**Government of India  
Ministry of Railways  
Research, Designs & Standards Organisation  
Manak Nagar, Lucknow - 226 011**

**MODIFICATION SHEET NO. WAM4/128**

**MODIFICATION TO FIXING ARRANGEMENT FOR BLOW OUT COIL OF  
CGR TO ENSURE LOCKING - TAP CHANGER NO. 32 TYPE**

MODIFIED FIXING ARRANGEMENTS FOR  
BLOW OUT COIL OF TAP CHANGER  
(No.-32)

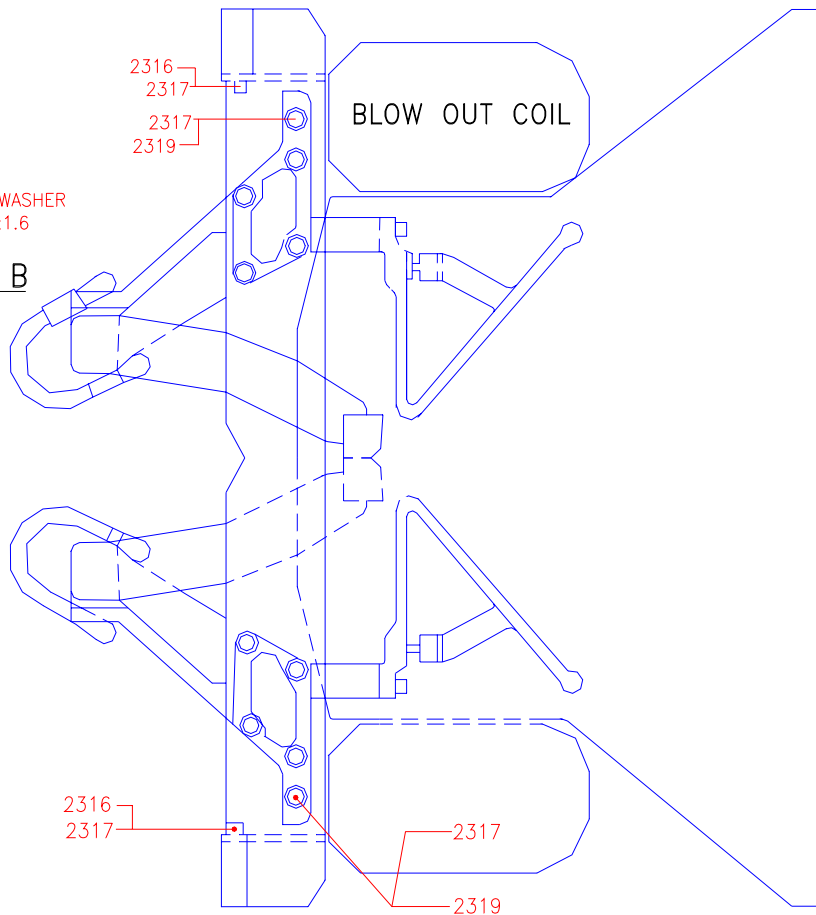
Railways have reported a few cases of loosening of Allen screws provided at locations 2316-17 and 2319-2317 for fixing the blow out coil of load switch (CGR) of tap changer type No. 32. Investigation has shown that HBB have provided only one number plain washer with allen screw. The original BBC practice was to provide 1 number spring washer with hexagonal bolt as shown in their Instruction Sheet No. AM 91018 E. This deviation from the original fixing arrangement caused the loosening of allen screws during service.

- Unscrew the allen screw provided at locations 2316-17 & 2319-2317
- Remove the allen screw (2316) and provide hexagonal screw (2316) with special locking washer, spring washer (2317) and necessary shim as shown in Fig. 1 of SK EL 3504.
- Provide the existing hexagonal socket head cap screw (2319) with spring washer (2317) and punched washer of dia 6.6/11 x 1.6 mm (Plain washer) as shown in Fig. 2 of SK EL 3504.
- Tighten fully the unscrewed hexagonal screws.
